Subject: **URGENT MEDICAL DEVICE CORRECTION**

Affected Product: ROSA One 3.1 Brain application

Affected Product: ROSA One 3.1 Brain application Field Action Reference: ZFA 2021-00198

ATTACHMENT 2 - Detailed sequence of events

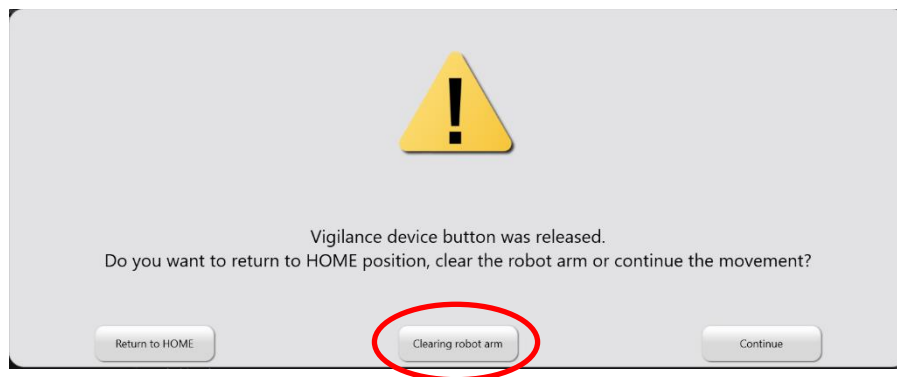
The sequences of events below may lead to the issue and should be avoided:

1. Launch ROSA One 3.1 Brain application.
2. Perform patient registration.
3. Go in guidance with a surgical tool mounted on the robot arm.
4. Shutdown the device while in guidance mode (the shutdown may occur unexpectedly or could be performed by the user).
5. Restart the device.
6. During movement of the robot arm, the vigilance device is released or a collision is detected by the software.
7. Select "Clearing robot arm".

If a shutdown occurs during guidance mode, any empty calibration window that would subsequently appear during the session should be closed by pressing UNDO.

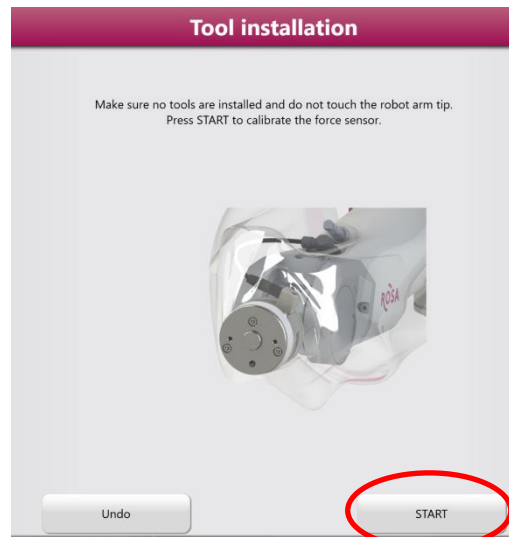
8. Software asks for an empty calibration of the force sensor.
9. Select "START" and perform the empty calibration.

10. Continue with the guidance and placement of instruments and/or implants.
11. The robot finishes the movement but the tool center point is not at the correct position.
